Response to Comments Document

Hazardous Waste Listing
Determination for Chlorinated
Aliphatics Production Wastes
(Final Rule)

Figure 1. Comparison of MINTEQ-Generated Kd Values to Literature Values

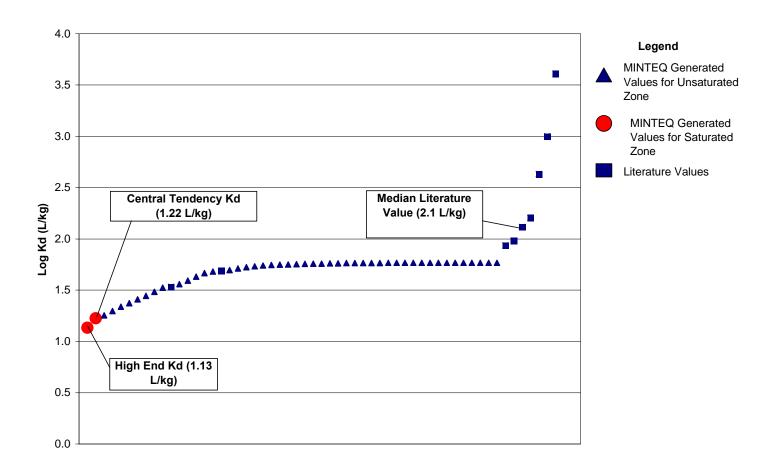
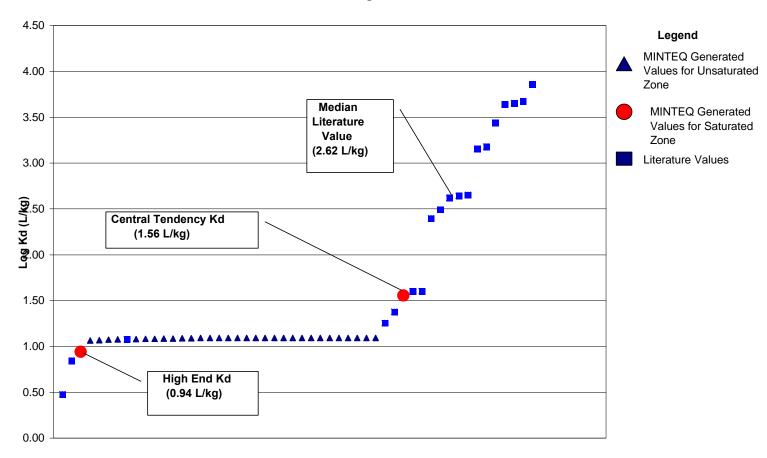
Issue 32. The report states: "For future risk calculation comparisons it would be useful to program CMTP to provide time-to-HBN [health-based number] in its output files."

For nickel, the K_d values reported in the literature range from 3 L/kg to 7250 L/kg, with a median value of 420 L/kg. These values represent sand aquifer systems with pH ranging from 5.28 to 8.87. Experimental system parameters are similar to those generally used in model simulations and the two sets of K_d values can be compared. As shown in Figure 2, two of the literature values are less than the range of model-generated values. One literature value falls within the lower end of the range and the majority exceed the model-generated values.

While the diagnostic output suggested by the commenter may provide useful information in cases where a health-based number and the peak concentration are very different, this is not the case in the chlorinated aliphatics analysis. In the chlorinated aliphatics analysis the groundwater pathway risk estimate for arsenic under the EDC/VCM landfill scenario was 3E-05. The groundwater pathway risk estimates for all other contaminants were 1E-05 or below (all hazard quotients were less than 1). The receptor well concentration that corresponded to the 3E-05 arsenic risk estimate was estimated to occur approximately 8800 years in the future. For reasons described in the final rule, EPA determined that the arsenic risk results were not of concern. In addition to the time it would take the peak arsenic concentration to reach the modeled receptor well, the predicted high end arsenic concentration at a receptor well (1.4 ppb) is very close to the median arsenic background concentration of 1.0 ppb found in groundwater in Texas and Louisiana. The predicted high-end arsenic concentration also is well below the current maximum contaminant level (MCL) allowed for arsenic in drinking water and below the revised MCL for arsenic recently-proposed by EPA's Office of Ground Water and Drinking Water. The current MCL for arsenic is 50 ppb, the revised MCL proposed by EPA is 5 ppb (65 FR 38888). Therefore, calculating the time required for the groundwater concentration in the receptor well to reach a concentration corresponding to a health-based number would not have been relevant in the case of the chlorinated aliphatics listing determination since the peak arsenic concentration was determined to not to be of concern.

EXHIBIT 13Industrial Ecology Life Cycle Depiction of CAHC-Based Plastics Manufacturing

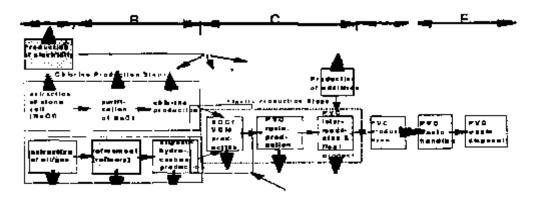
As shown in Exhibit 13 the plastic "process" from which the "listing proposal" waste is generated is the process where chlorine is added to the aliphatic hydrocarbon - the EDC/VCM production unit. Waste from the other plastic production units which include the PVC resin production unit and the PVC intermediates and final production unit are not included in the proposed listing.

Industrial Ecology Life Cycle Depiction of CAHC Solvent Manufacturing

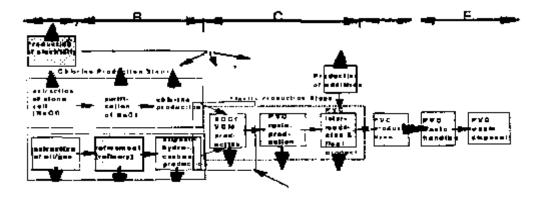
As shown in Exhibit 14 the solvent "process" from which the "listing proposal" waste is generated is also the process where chlorine is added to the aliphatic hydrocarbon - the apply-named Chlorination of hydrocarbons production unit. Waste from the other solvent production units which include the solvent recycling units are not included in the proposed listing.
